Proposal Description

ANALYSIS — COUNCIL LAND USE ACTION

RECOMMENDATION – COUNCIL APPROVALS

① ROOF PLAN
1/16" = 1'-0"

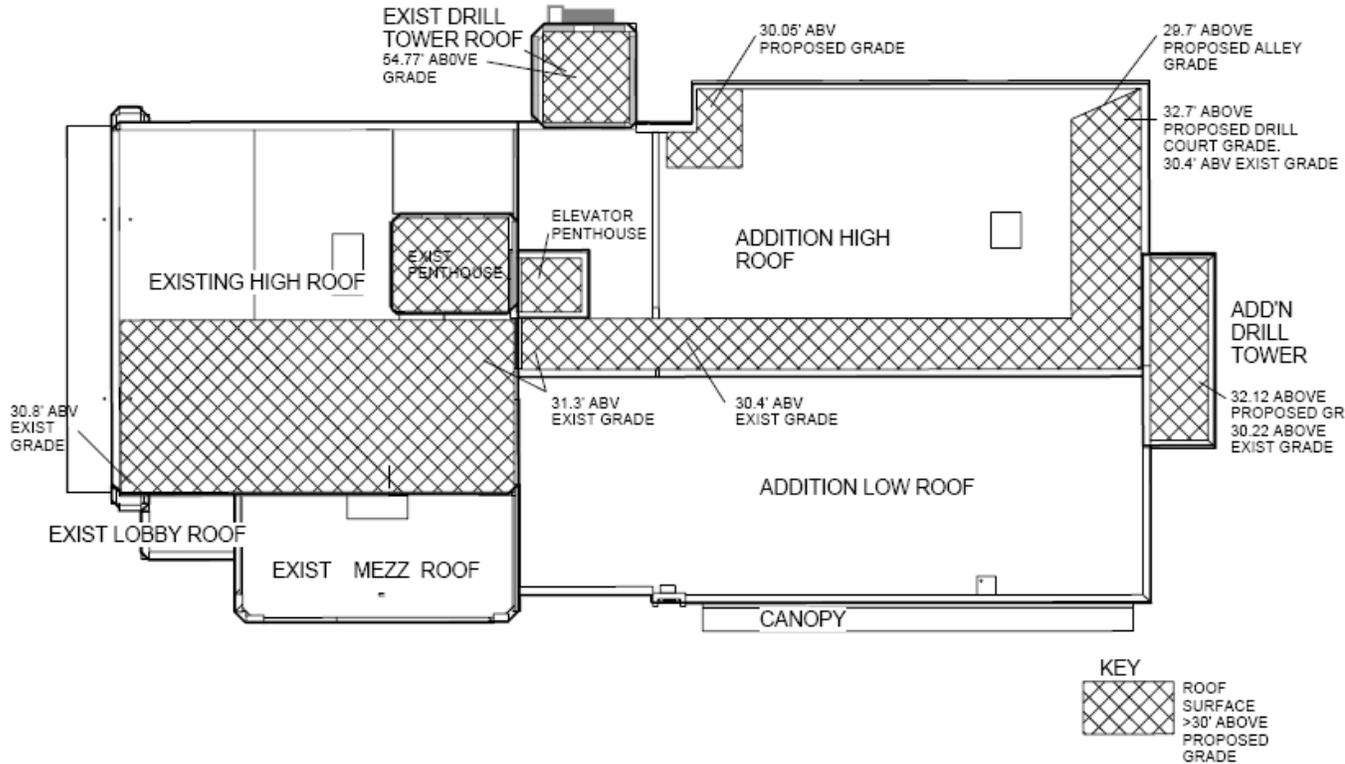
A modification is requested to exceed the base height allowed in the Lowrise 3 zone by up to 3 feet. The proposed design exceeds the 30 foot height limit by less than an inch to 3 feet. The Lowrise 3 zone allows structures with pitched roofs to exceed the base height limit by up to 5 feet. The code also allows height exceptions for elevator and stair penthouses. There are no exceptions for flat roof structures as in this design. The plan below shows where portions of the roof are over the height limit.

The modification for height should be approved based on the above factors.
